Ref: ABP-313591-22

INTRODUCTION

South Dublin County Council hereby sets out its Chief Executive's Report, including recommendations on the above Strategic Housing Development for An Bord Pleanála (ABP or The Board). The Board as the competent authority has validated the application, and will carry out an Appropriate Assessment Screening of the proposed development, and will decide to grant or refuse permission for the proposed development.

Observation

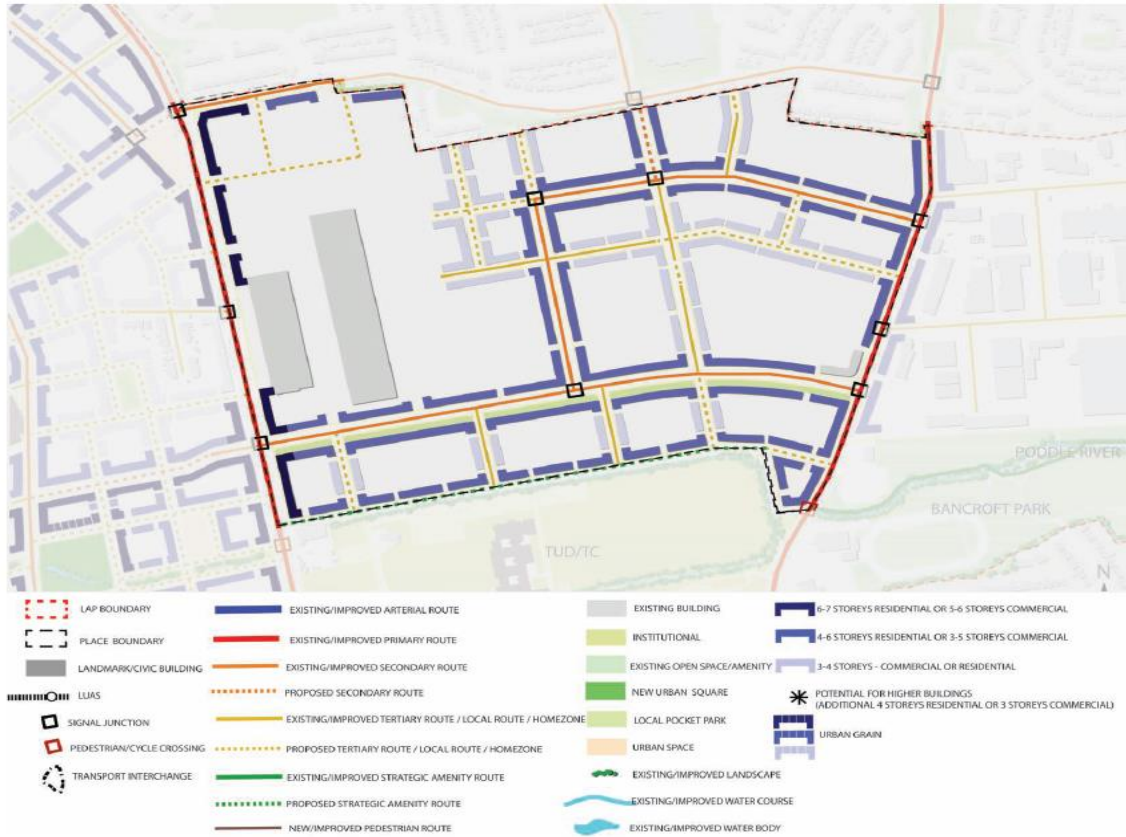
A masterplan is required to ensure a coordinated approach to the proposed development. It is important to understand how the design will fit in relation to future neighbouring developments. It is important to maximise the pedestrian, cyclist, and vehicular permeability throughout the site and to the wider masterplan area. A design of the road, footpath and cycle lane for the development in line with the LAP for Tallaght is required.
